SUBJECT: REMOVAL OF CYCLE SPECIFIC PARAMETER LIMITS, REQUEST NO. 89-13  
(TAC NOS. 76053 AND 76054)

RE: LIMERICK GENERATING STATION, UNITS 1 AND 2

AMENDMENT TO FACILITY OPERATING LICENSE

Amendment No. 37  
License No. NPF-39

CONTROL ROD BLOCK INSTRUMENTATION SETPOINTS

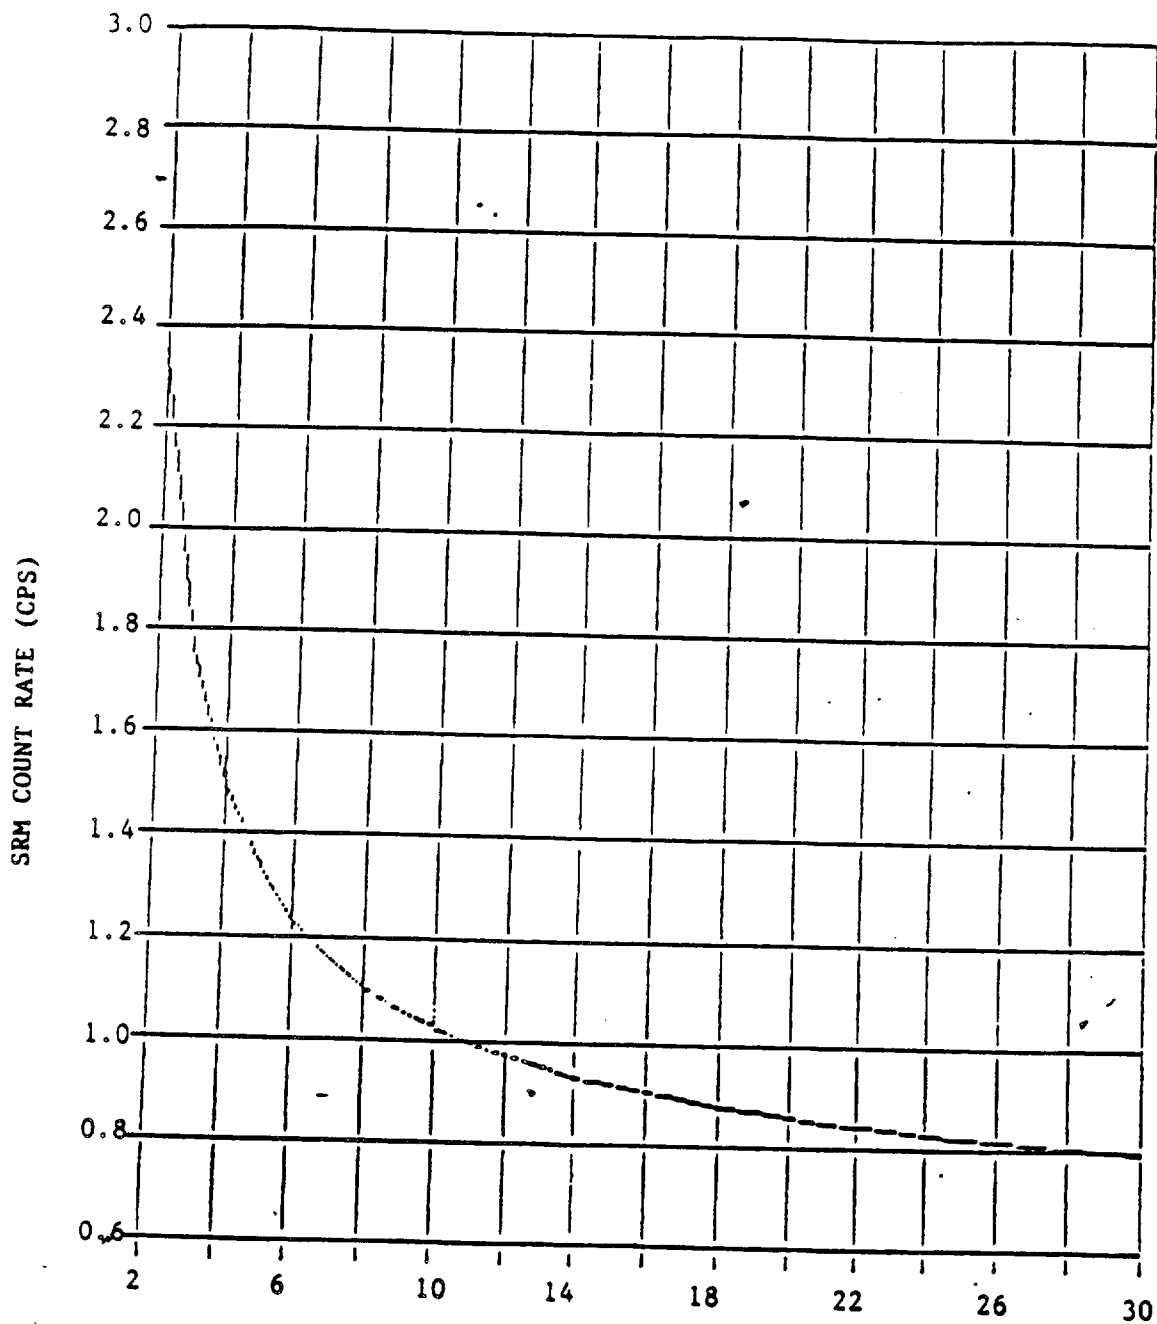
- iii. Revise Section 3/4.2.4, "Linear Heat Generation Rate (LHGR)," to reference the COLR for limiting values.
  - iv. Revise Section 3/4.3.6, "Rod Block Monitor (RBM)," Table 3.3.6-2, Trip Function 1.a (RBM upscale) by replacing the RBM high flow clamped setpoint of 106 with the constant "N." Revise all other cycle specific constants to functions of "N" (e.g., change 109 to (N+3)). The value of "N" is a cycle specific limit and is therefore referenced in the COLR.
